The manuscript describes a statistical (machine learning) approach to derive the uncertainty of wind data from mesoscale model simulations for longer time periods. The topic is relevant for wind energy. Thus, the manuscript should be published after revisions.

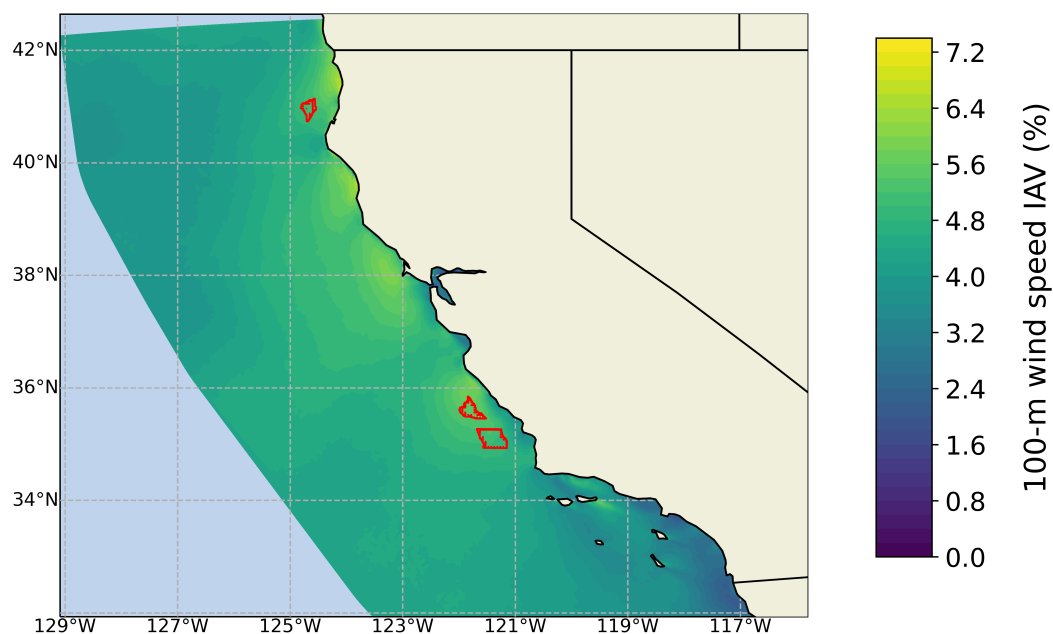
(5) This study addresses uncertainties in wind speed. How does the magnitude of these possible uncertainties in wind speed modelling relate to, e.g., interannual wind speed changes due to long-term oscillations in the global circulation (NAO etc.) or due to climate change?
Assessing the impact of climate change and/or long-term oscillations is strictly outside the scope of our manuscript. However, to guide the interested reader in this analysis, we have calculated the interannual variability in modeled 100-m wind speed from the 20-year record used in the analysis, and included the following map in the Supplementary Materials:

Also, we have added the following sentence at the end of the Conclusions:
"Finally, future work could focus on how interannual wind speed variability caused by climate change or long-term climatic and atmospheric oscillations (e.g., the North Atlantic oscillation) compares with the quantified uncertainty in modelled wind speed and how that should be taken

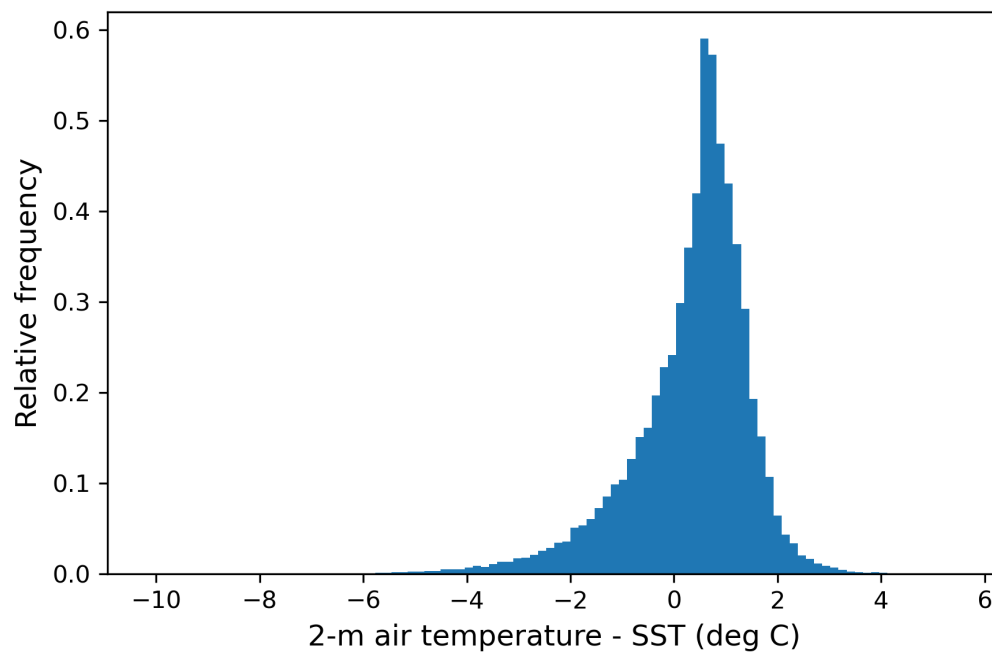
(6) Figure 7: Why do unstable thermal stratification conditions have such a small share of all cases? Shouldn't the lagged annual SST variation (due to the much larger thermal inertia of the water) compared to the air temperature variation lead to roughly equally frequent stable and unstable situations (stable in late winter and spring, unstable in late summer and autumn)? Please give an explanation for the found bulk Richardson number distribution.

To justify the distribution of bulk Richardson number, we have calculated the difference between air temperature and sea surface temperature at the considered site, using the 20-year WRF data:

As the histogram shows, the air temperature is generally higher than the sea surface temperature, likely because of ocean upwelling in the region, which leads to a generally cold sea water. This induces a stable stratification, which justifies the distribution of bulk Richardson number found and reported in the paper. We have added a comment on this in the paper, too ("This is consistent with the sea surface temperature being generally colder than the near-surface air (because of ocean upwelling), which causes a predominantly stable stratification.").
